**H.Y. ENGINEERING FILE: 174762**

**PORT COQUITLAM PROJECT: SUB00169**

**RE: PROPOSED SINGLE-FAMILY SUBDIVISION LOCATED AT 1160 VICTORIA DRIVE, PORT COQUITLAM, BC**

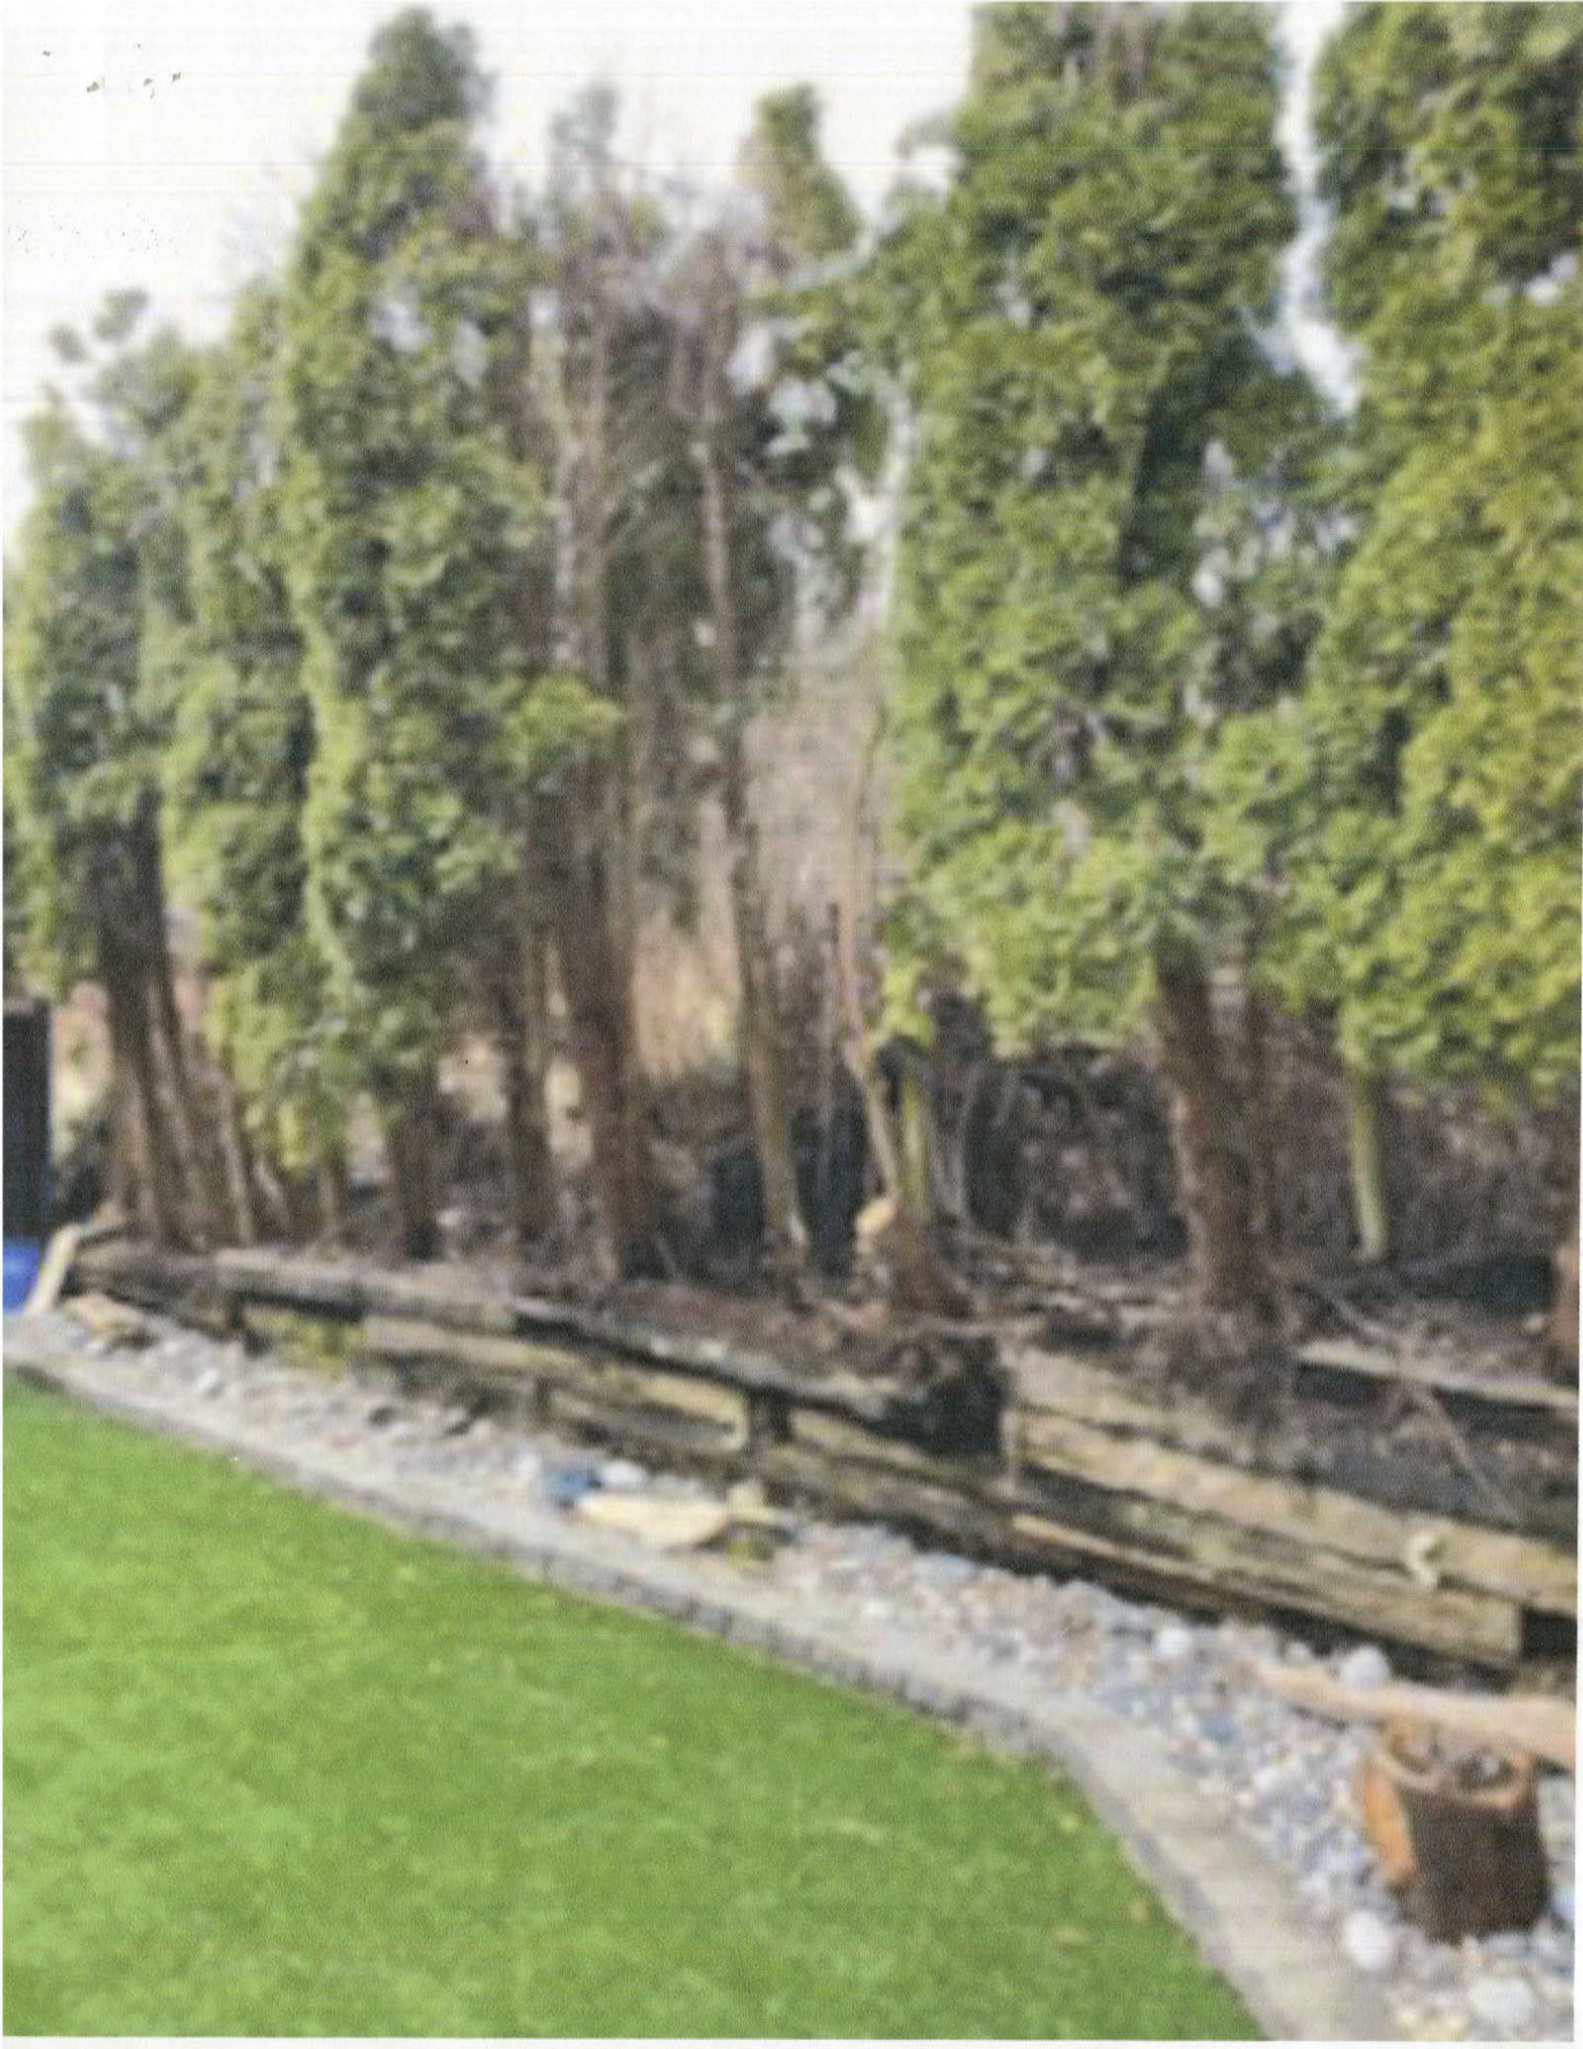
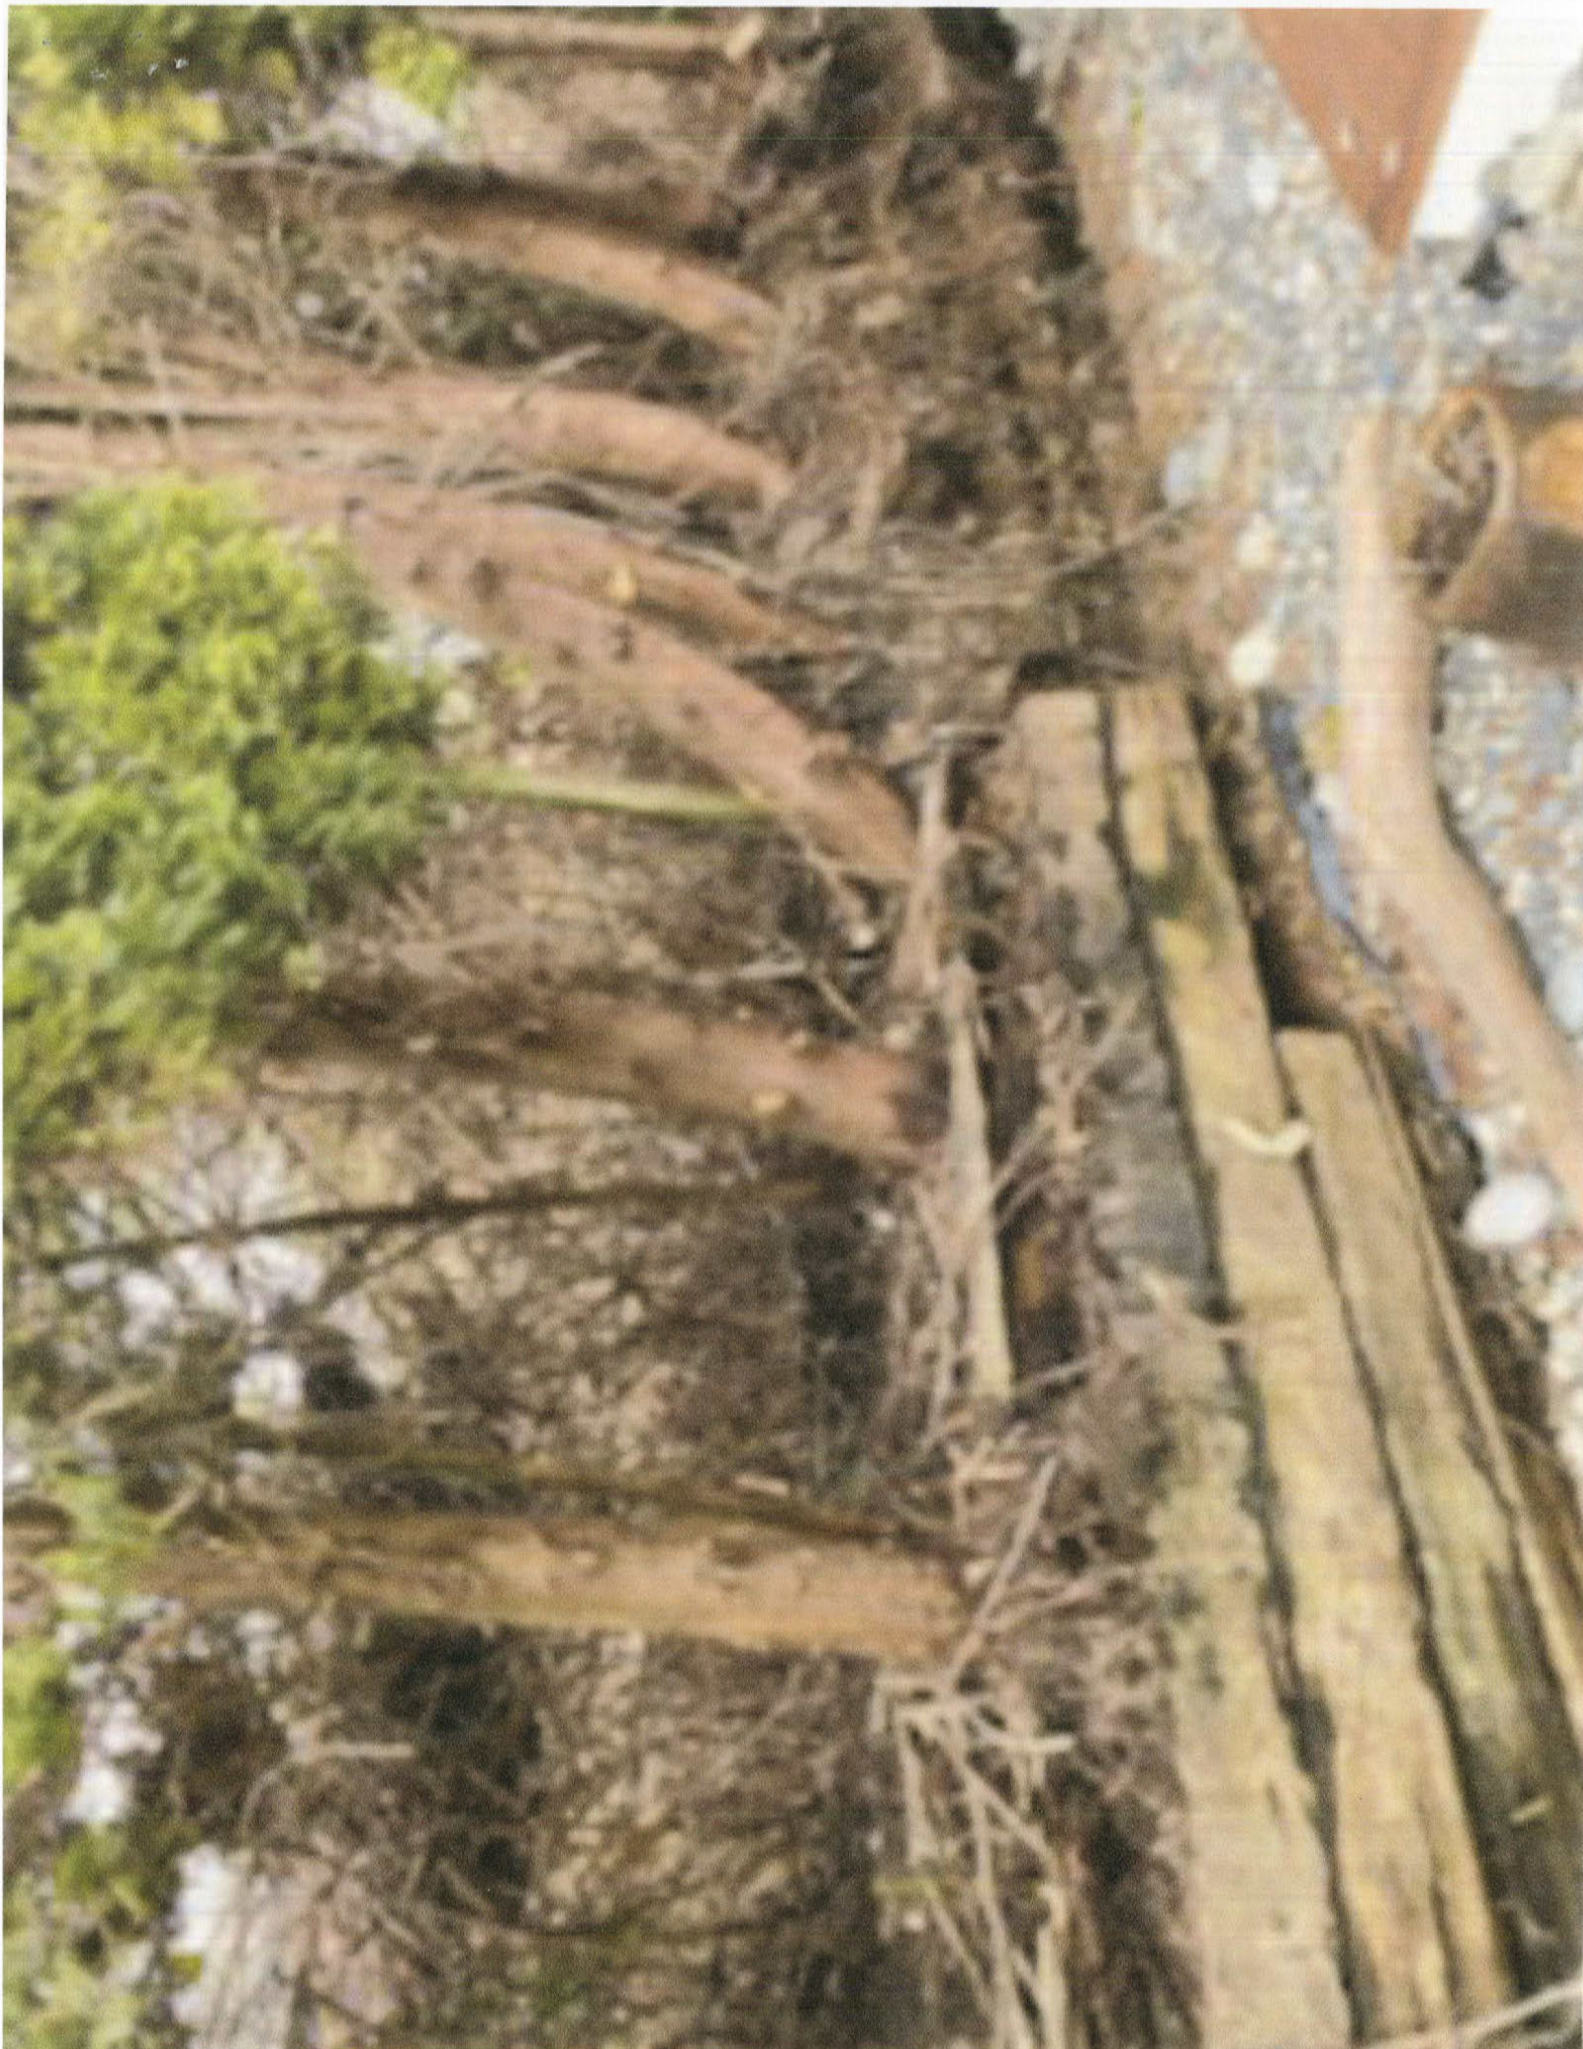
There are hedges on the proposed property that have been leaning into our yard for years. Remove them build a fence and we are happy. Preference would be no upper balcony/decks as you've already stated. It would be great if Victoria could be used initially to clear it so dump trucks could exit on Victoria in initial stage. We just want the hedges gone/fence built.

☐ We do not support the project because: We would also like to know how the grade change will be addressed. Retaining wall?  
Pics enclosed
